ADDENDUM NO: 1

PROJECT: **SITE IMPROVEMENTS AT FRANKLIN CENTRAL JUNIOR HIGH**

CONTEXT PROJECT NO: 22-1613 DATE: 2/13/2024 BY: Fred Prazeau

Sheet No:
C400

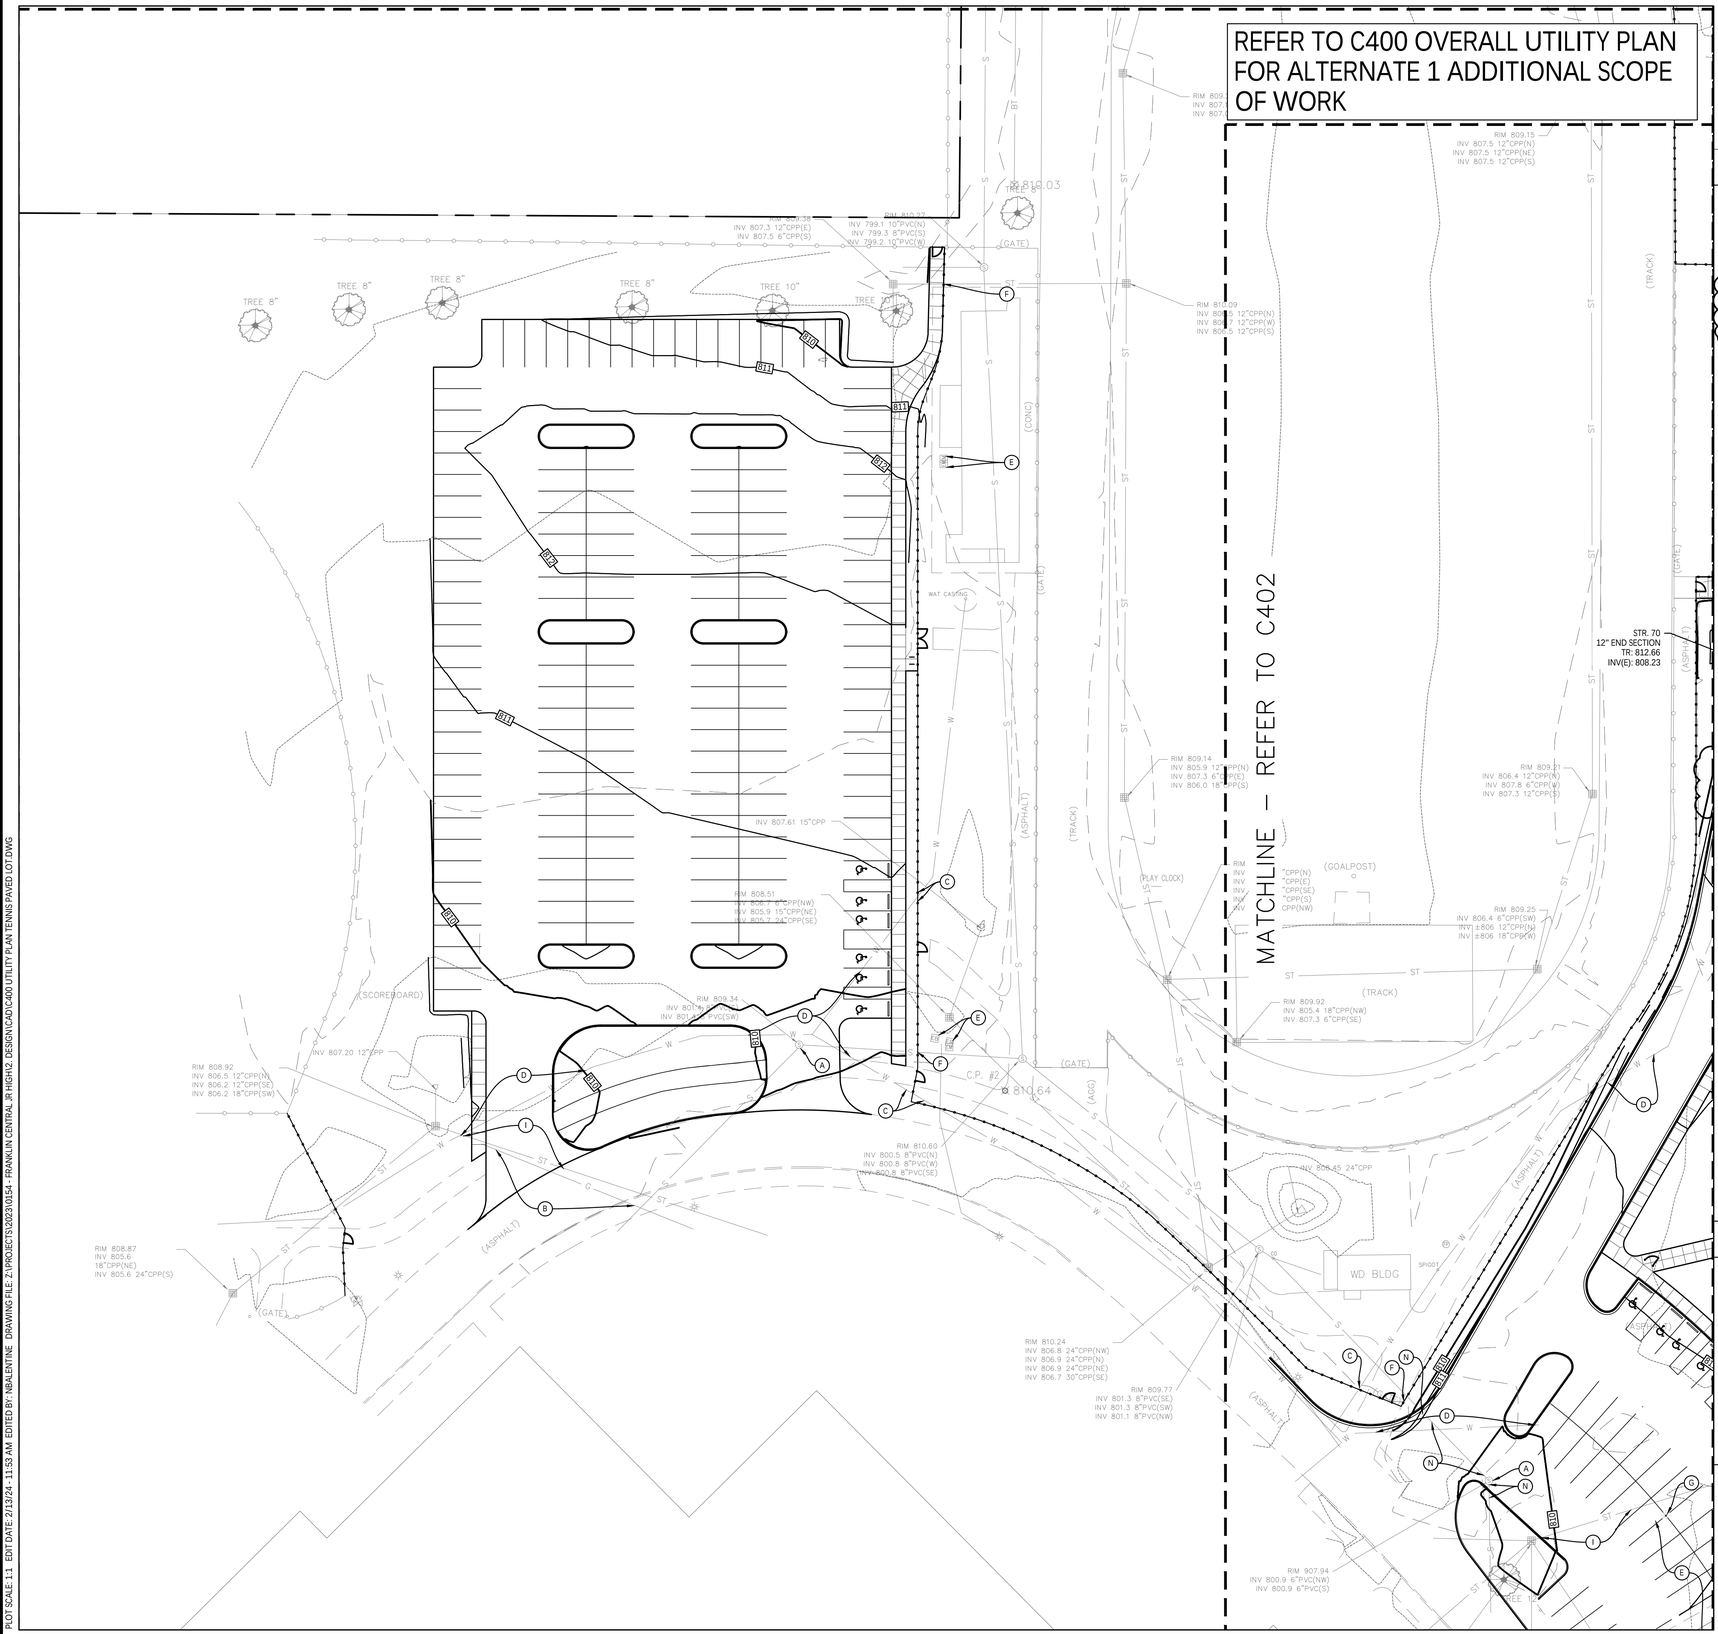
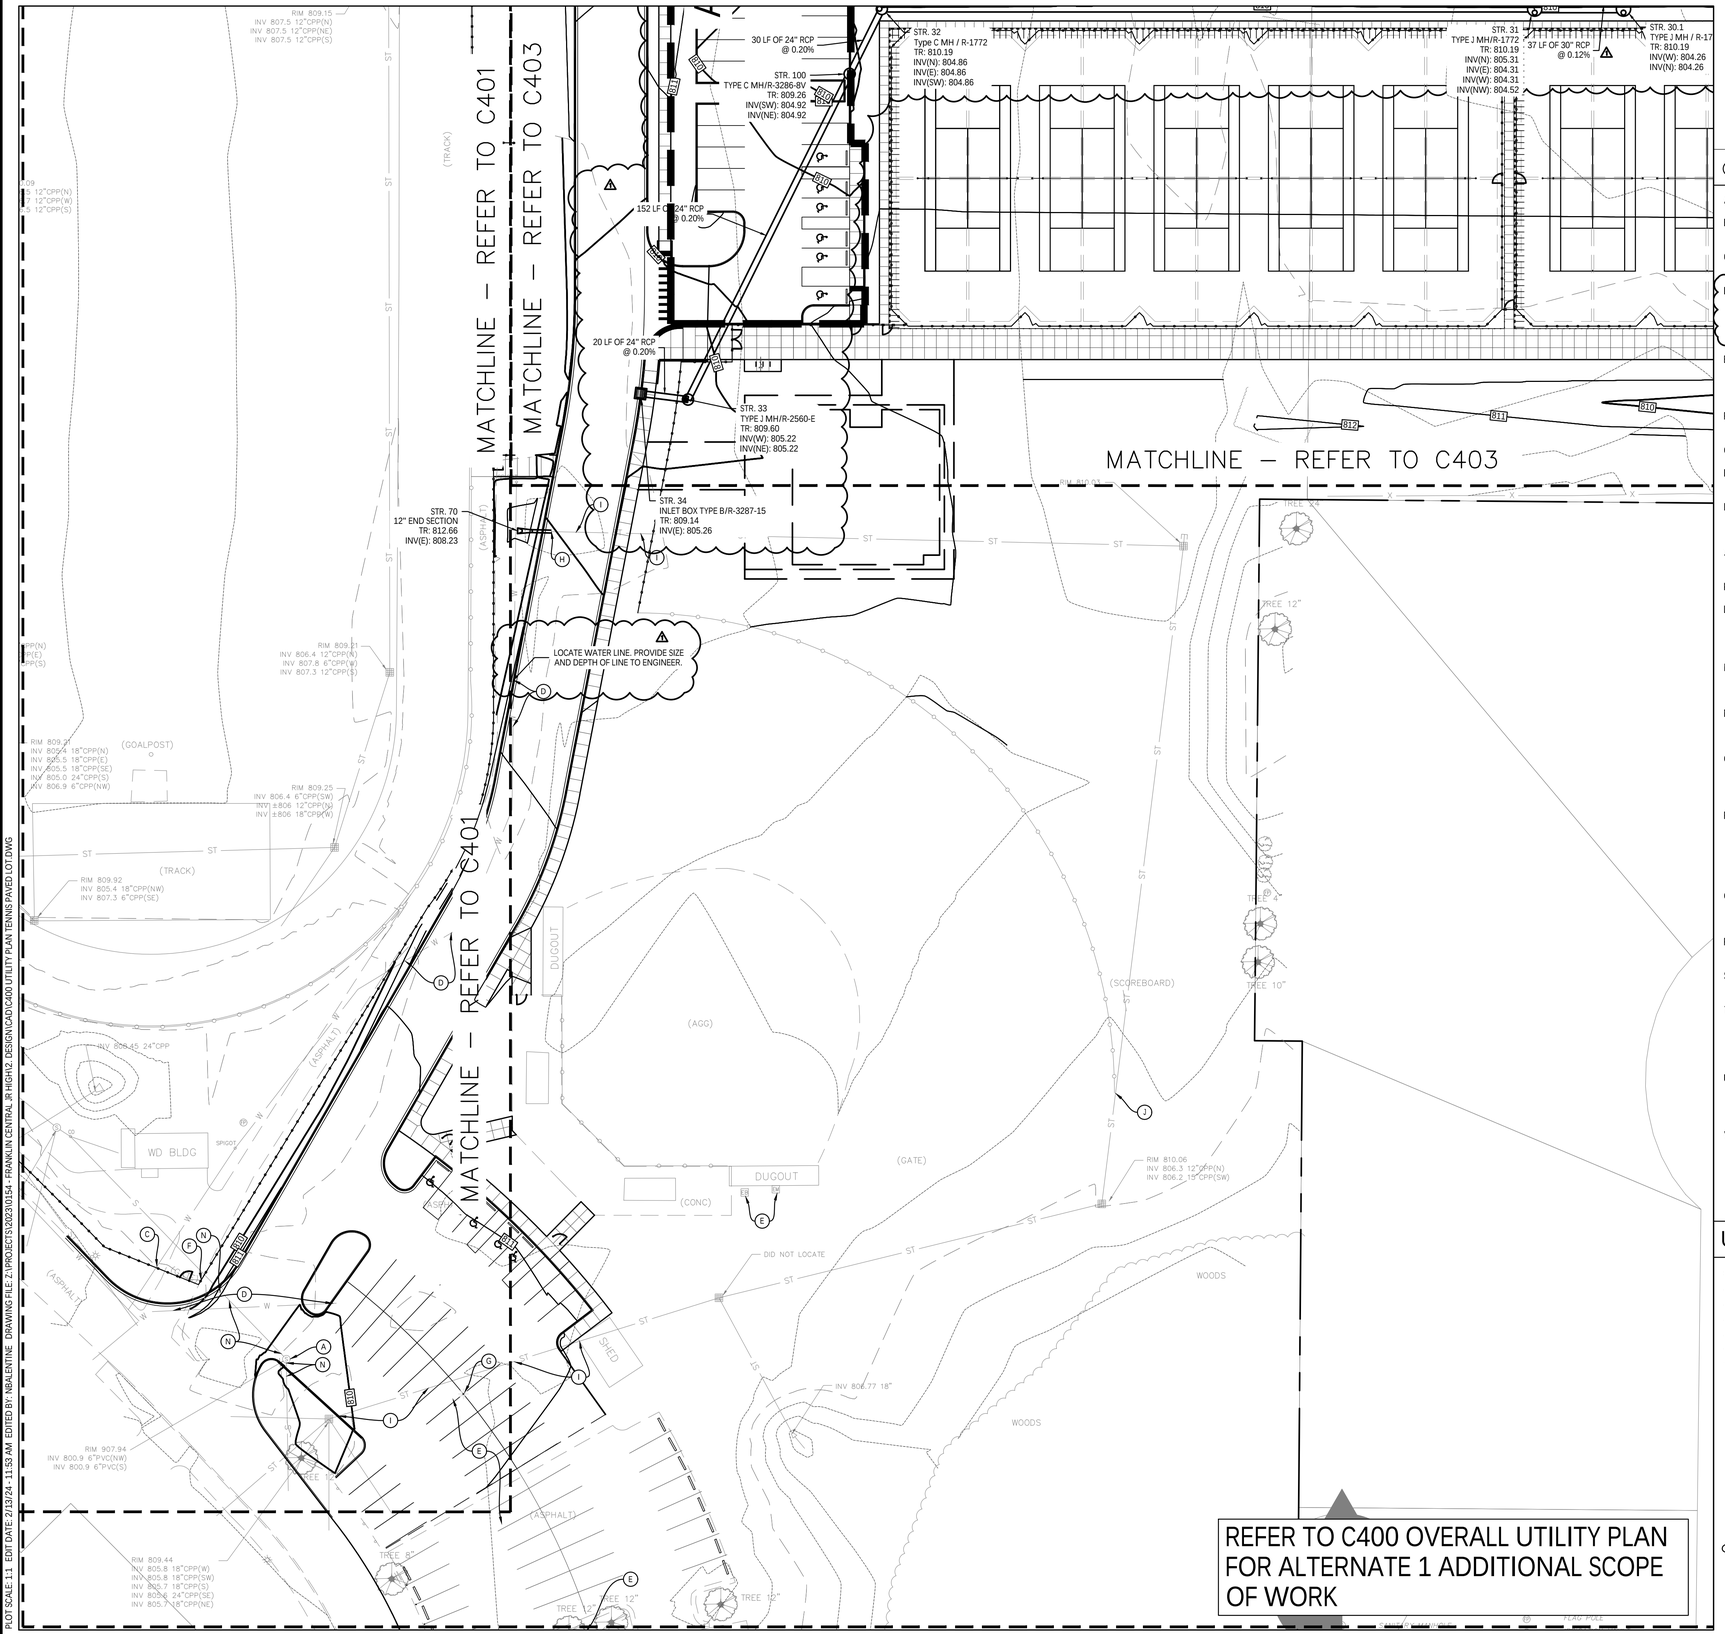
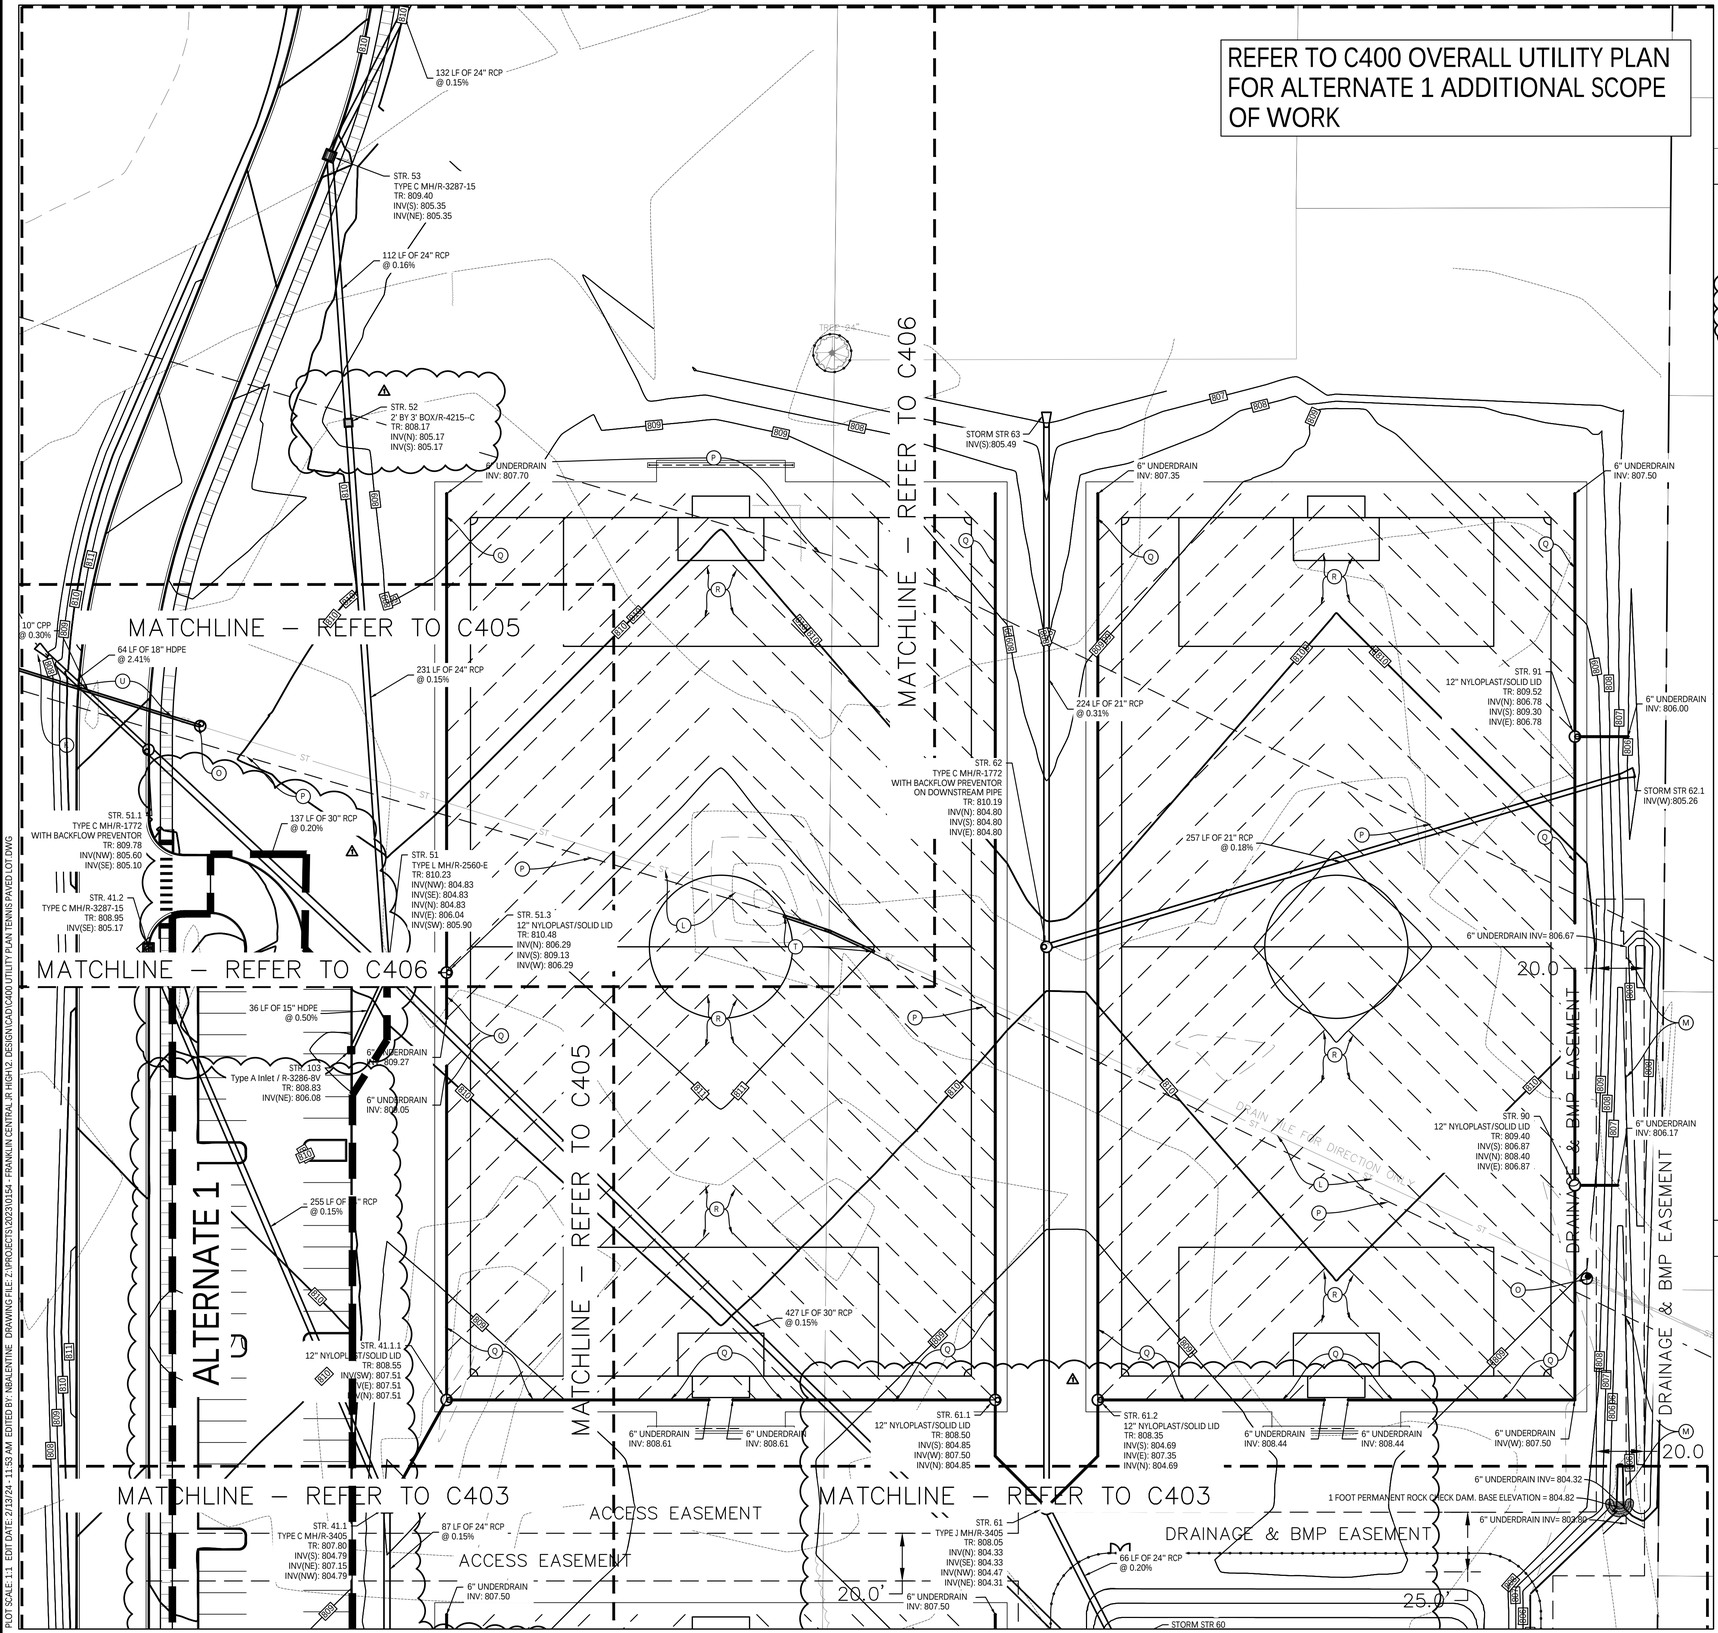
3. C400-Series Utility Plans reissued to address City comments, including clarification to storm structures to reflect grading revisions and sufficient cover, subsurface drainage as indicated on plans, storm structure network for Alternate #1 – Soccer Parking, and relocation of sprinkler vault in the vicinity of the soccer lot.
